**INVITATION OF VENDOR COMMENTS ON QR/ TDs OF MODULAR
KILL HUT/ SHOOT HOUSE WITH ADVANCED TARGET SYSTEM**

DRAFT QRS AND TDS OF MODULAR KILL HUT/ SHOOT HOUSE WITH ADVANCED TARGET SYSTEM

विषय:- **FORWARDING OF DRAFT QRs AND TDs OF KILL HUT/ SHOOT HOUSE
WITH ADVANCED TARGET SYSTEM FOR SUGGESTION/ COMMENTS**

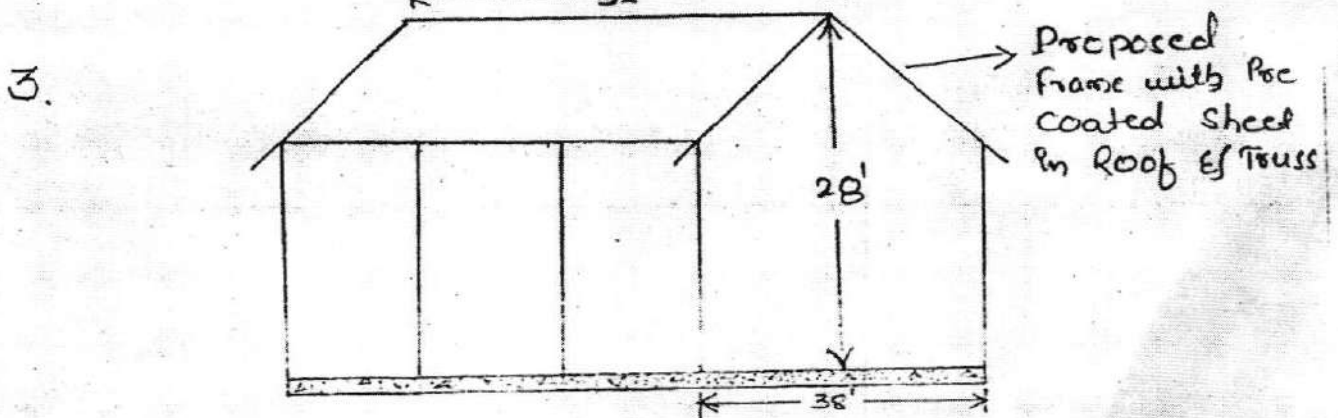
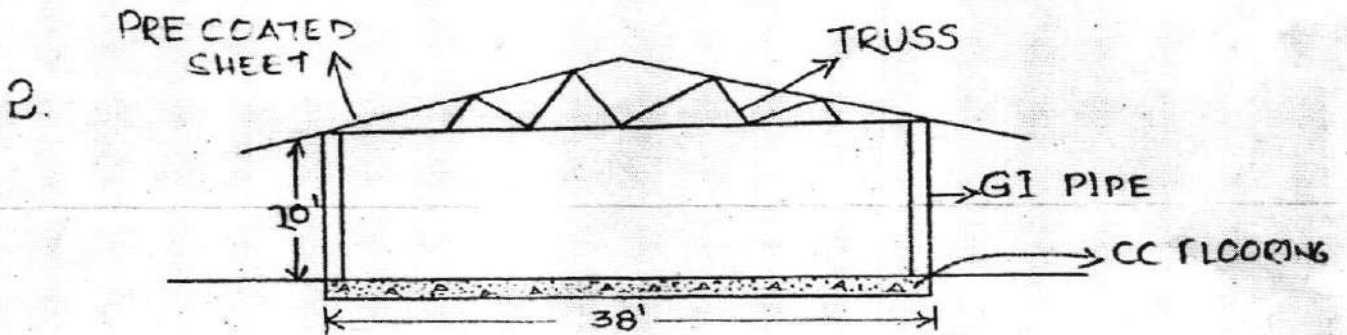
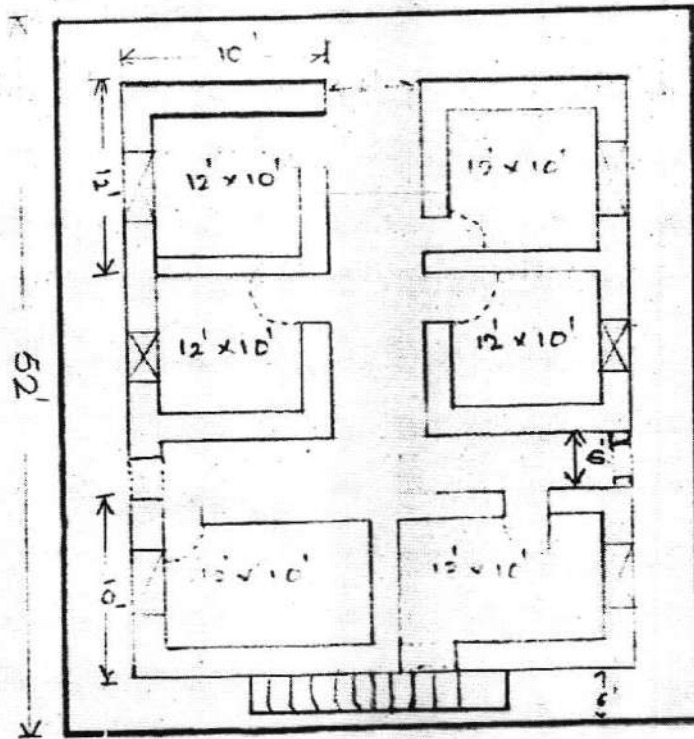
1. As per General parameter at S. No. 1 para (d) of specification, stairway is also required in the Modular Kill Hut. Sketch to be modified accordingly.
